STAFF REPORT
COMMUNITY DEVELOPMENT DEPARTMENT

HEARING DATE: December 1, 2022
 TO: Planning & Zoning Commission
 FROM: Sonya Allen, Associate Planner
 208-884-5533
 SUBJECT: H-2022-0065 – West Valley Emergency Center – MDA, CUP, ALT
 LOCATION: Southwest corner of N. Levi Ln./N. Rustic Oak Way, in the NW ¼ of Section 28, Township 4N., Range 1W. (Parcel #R699122250)

I. PROJECT DESCRIPTION

B. Proposed Phasing Plan for Hospital/Medical Center Site

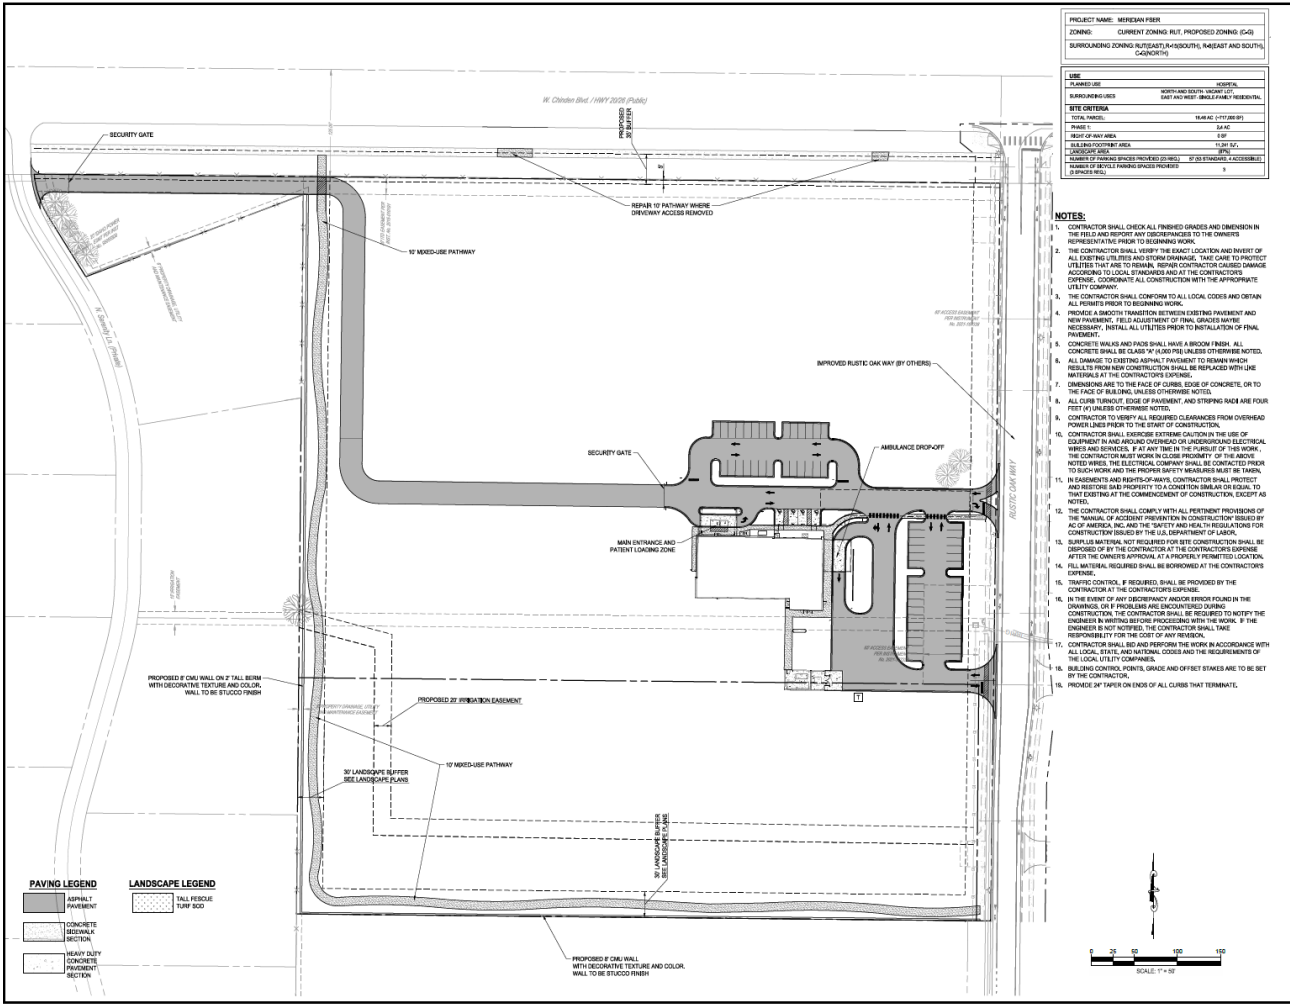
The existing phasing plan is for the overall Prescott Ridge development, which is being developed separately from the proposed development. A phasing plan for the subject property is proposed to replace the existing plan. The emergency room and perimeter buffers along the north, west and south boundaries of the site are proposed to develop with the first phase; the medical office building with retail and restaurant uses is proposed to develop with the second phase; and the hospital is proposed to develop with the third and final phase of development. The collector street (Rustic Oak Way) and associated street buffer will be constructed by the developer of Prescott Ridge Subdivision with their first phase of development. *See phasing plans in Sections VIII.A & B. Staff is supportive of the proposed change to the*

phasing plan that includes more detailed phasing for the subject property and separation from the residential portion of the development under separate development.

1. The phasing plan included in Section VIII.B shall replace the original phasing plan in the existing Development Agreement (DA) (Inst. #[2021-132724](#)).
2. Provision #5.1.3 in the existing agreement shall be modified as follows, “Noise abatement shall be provided in the form of a berm or a berm and wall combination parallel to W. Chinden Blvd./SH 20-26 constructed in accord with the standards listed in UDC 11-3H-4D or by an alternative compliance proposal as defined in UDC 11-3H-4D.4.”

D. Landscape Plan (dated: 7/22/2022) – [full plan set](#)

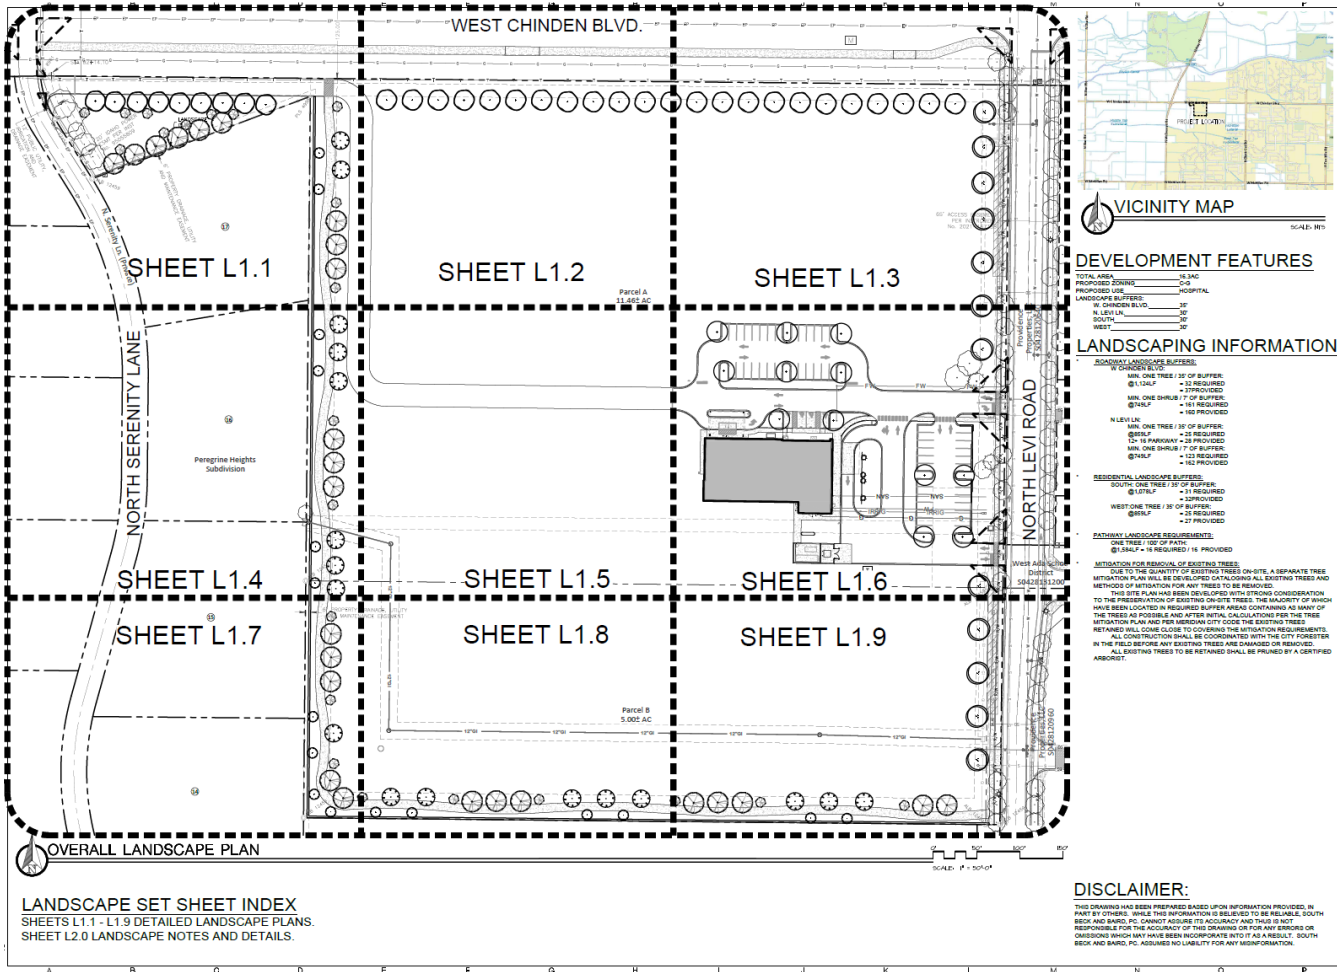
Landscaping: A 35-foot wide street buffer is required to be provided on this site along W. Chinden Blvd./SH 20-26, an entryway corridor, landscaped per the standards listed in UDC 11-3B-7C. The street buffer is measured from the back of curb; where the transportation authority is anticipating future widening of the street, the width of the buffer is measured from the ultimate curb location. There is a large expanse of land within the right-of-way along Chinden that can be counted toward the street buffer requirement if landscaped per the standards in UDC [11-3B-7C.3](#); landscaping may be allowed through a license agreement with ITD. Because this is an entryway corridor, enhanced landscaping should be installed in accord with the standards listed in UDC [11-3B-7C.3](#). **A revised landscape plan should be submitted with the Certificate of Zoning Compliance application that reflects compliance with standards listed in UDC [11-3B-7C](#), including enhanced landscaping along the entryway corridor (i.e. Chinden Blvd).**

Alternative Compliance is requested to the landscape standards in UDC 11-3B-7C.3, which require a minimum density of one (1) tree per 35 linear feet along with shrubs, lawn or other vegetative groundcover, to be installed within the street buffer along W. Chinden Blvd. On the western portion of the site, the buffer area is constrained where the emergency access road is proposed to the north of Peregrine Heights Subdivision. In this area, the trees are proposed on the south side of the driveway. Because driveways are an allowed impervious surface in street buffers and the required number of trees are proposed on the south side of the driveway, Staff sees no purpose for the request as the proposed landscaping appears to meet UDC standards; thus, Staff recommends denial of the request.

Staff is amenable to the Applicant's proposal to located the building 400+ feet to the south of the state highway to lessen the noise impacts as proposed; however, Staff recommends a minimum 3-foot tall berm with no less than 4:1 slope is provided within the street buffer for aesthetic reasons (i.e. to screen the parking area) since the site is located along an entryway corridor into the City, consistent with UDC [11-3B-7C.3f](#).

- b. Depict a minimum 35-foot wide street buffer along W. Chinden Blvd. with landscaping in accord with the updated standards listed in UDC [11-3B-7C.3](#). Enhanced landscape design features shall be provided within the street buffer along Chinden Blvd., an entryway corridor, in accord with UDC [11-3B-7C.3f](#), including a minimum 3-foot tall berm with no less than 4:1 slope to screen the parking area. Include calculations that demonstrate compliance with the standards. *Landscaping may be allowed within the right-of-way along Chinden Blvd. with a license agreement with ITD.*

7. Comply with the standards listed in UDC 11-4-3-22 for hospitals.
8. The Applicant’s request for Alternative Compliance to the noise abatement standards listed in UDC 11-3H-4D was approved by the Director with the condition a minimum 4-foot tall berm is installed within the street buffer along W. Chinden Blvd.
